**FW: PMR Questions**

**From:** Kliphuis, Trais
**Sent:** Thursday, January 31, 2013 4:04 PM**To:** Basabilvazo, George - DOE**Cc:** Cobrain, Dave, NMENV; Maestas, Ricardo, NMENV; Holmes, Steve**Subject:** PMR Questions

Below are a few questions and requests regarding the current Class 2 PMR. Please let me know if you have concerns or questions.

Figure C-2  
Waste Characterization Process

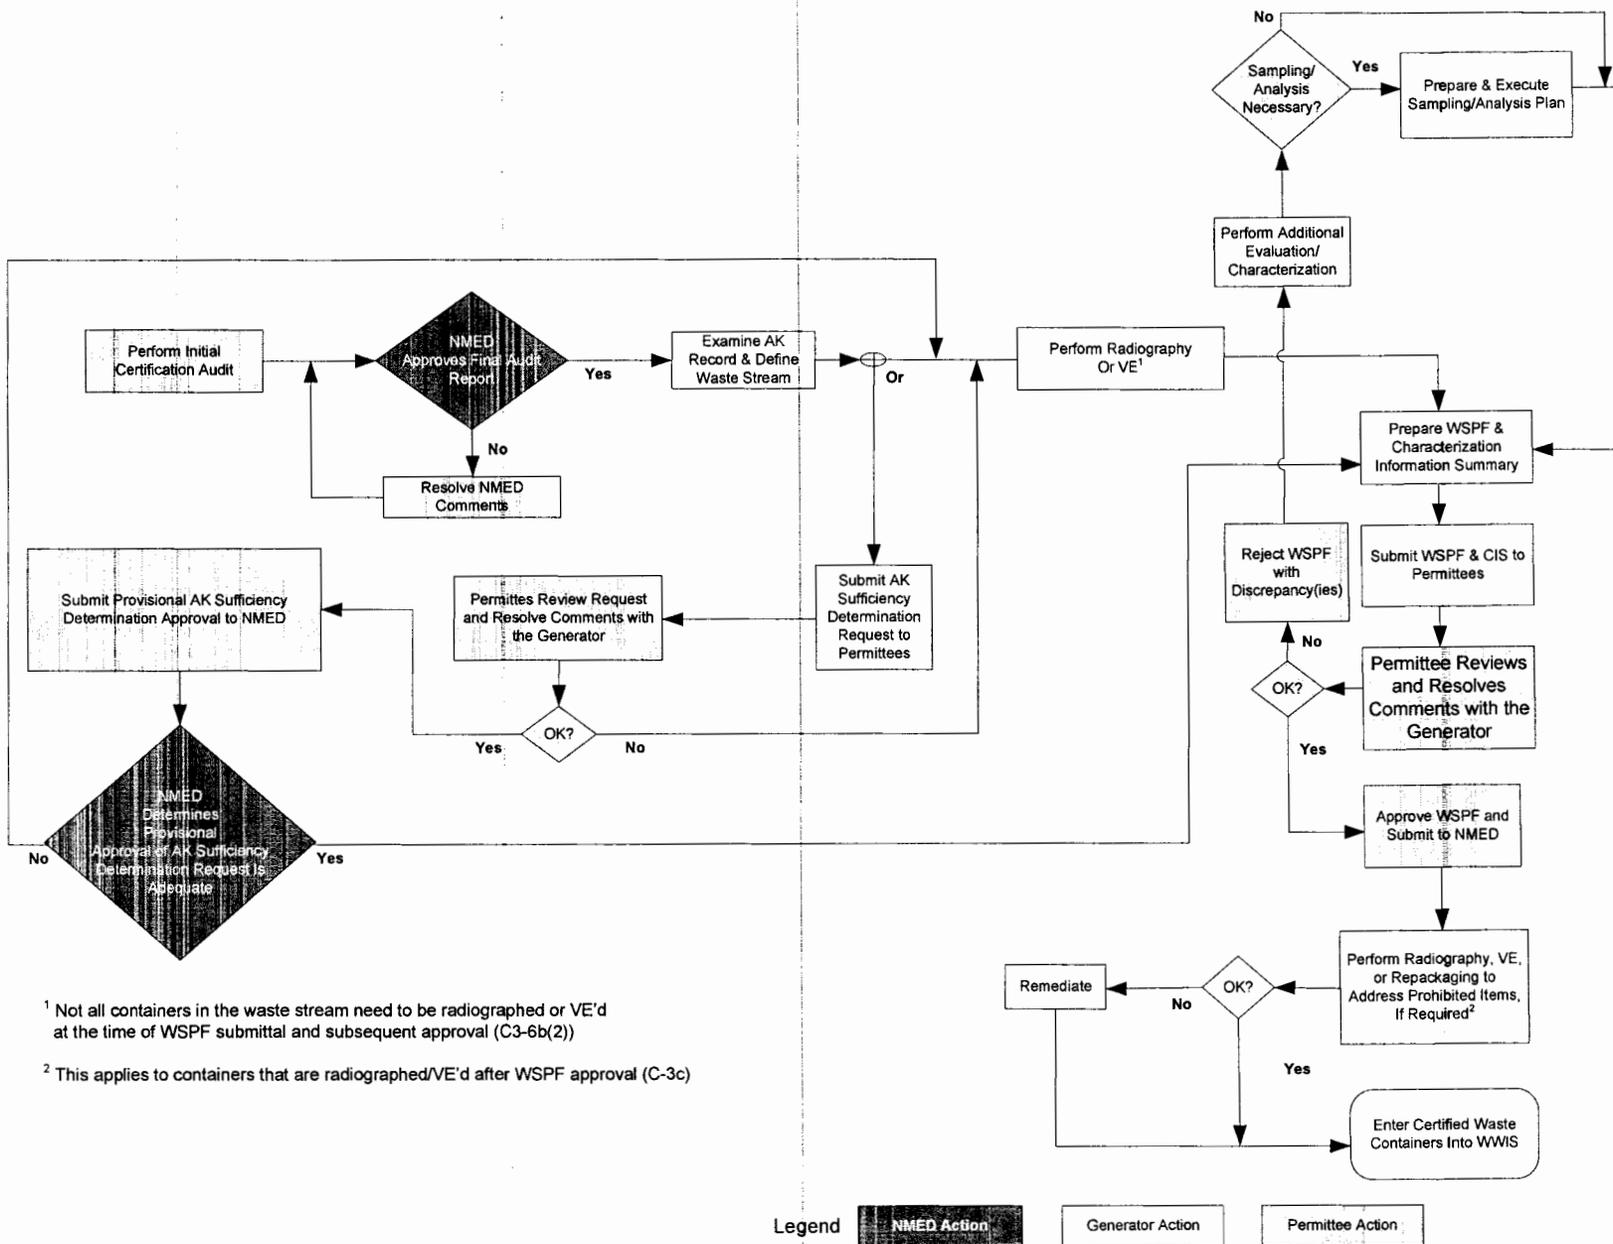
Please send a version of Figure C-2 Waste Characterization Process that has the changes accepted so that we may review a final version.

Please send a version of Figure C-2 Waste Characterization Process that has the changes accepted so that we may review a final version.

**Permittee Response:** Please see attached file. This figure has been revised to be consistent with the revision which will be submitted with the Permittees' comments on the PMR.
